Re: *Addendum No. 2*
Lakeshore East Equalization Basin Phase 2
City of Willoughby

Date: October 28, 2025

**CITY OF WILLOUGHBY
LAKESHORE EAST EQ BASIN
PHASE II**

PROJECT NO.	
230264	
DISCIPLINE	
ELECTRICAL	
SHEET NAME	
E-06	
SHEET	OF
47	48

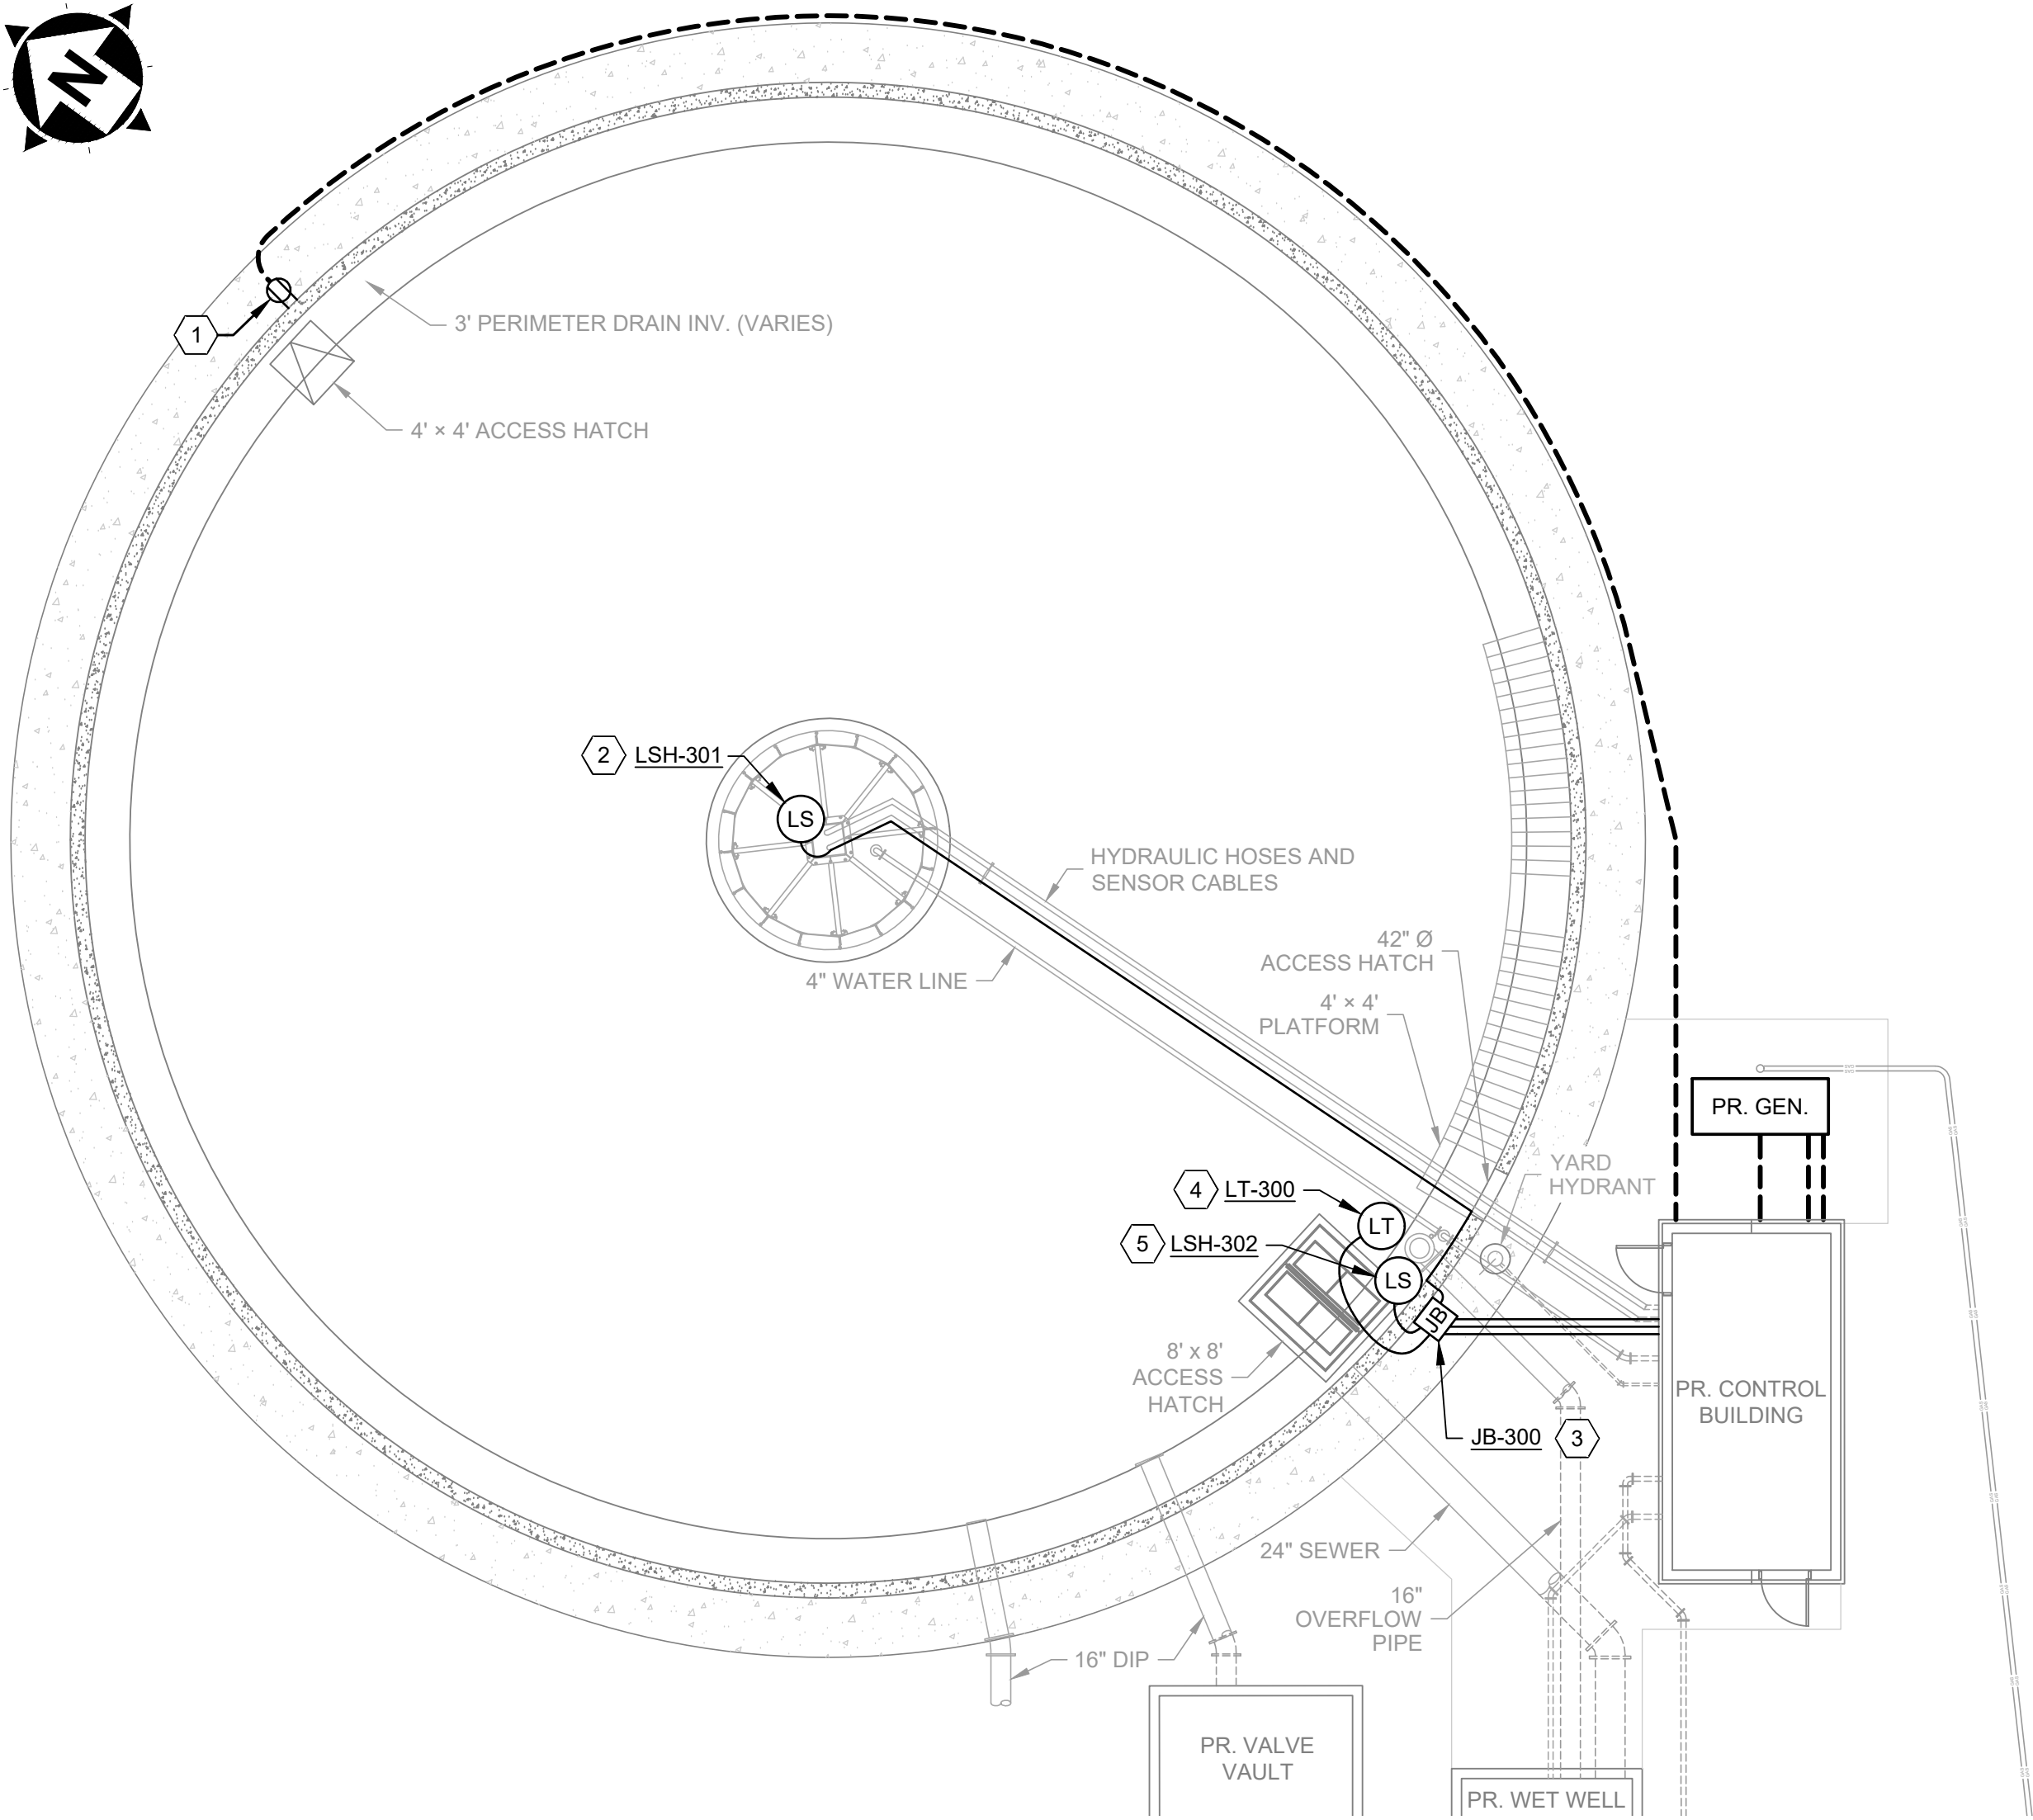
1. Contractor shall install radar level sensors within a 7-inch access cover. Access covers shall be cast iron, 3-inches in height, set in the concrete top of the wet well. Access cover shall be a Sioux Chief Series 850. The tank manufacturer shall provide an access cover for the radar sensor on the top of the dome. The cover shall have vandal-resistant cover screws.

Access covers shall be located over non-turbulent areas in each structure.

The radar sensor shall be provided on a stainless steel bracket, attached to the concrete within the access hatch. Phase 1 contractor shall install access cover in the Regulator Structure. Phase 2 Contractor shall provide stainless steel bracket, radar sensor, and perform installation.

- RADAR LEVEL SENSOR "LT-300", VEGA MODEL# VEGAPULS C 21, 4-20 mA LOOP POWERED, INSTALL IN A WAY TO AVOID ANY PROCESS PIPING OR OTHER OBSTRUCTIONS BETWEEN SENSOR FACE AND BOTTOM OF TANK. ORDER WITH MANUFACTURER'S CABLE LONG ENOUGH TO REACH JB -300. USE SS EXPLOSION-PROOF CONDUIT BODIES & SEALS TO ROUTE CABLE THROUGH TANK WALL BEFORE TERMINATING IN JUNCTION BOX WITH NEMA 4X CABLE GLAND.
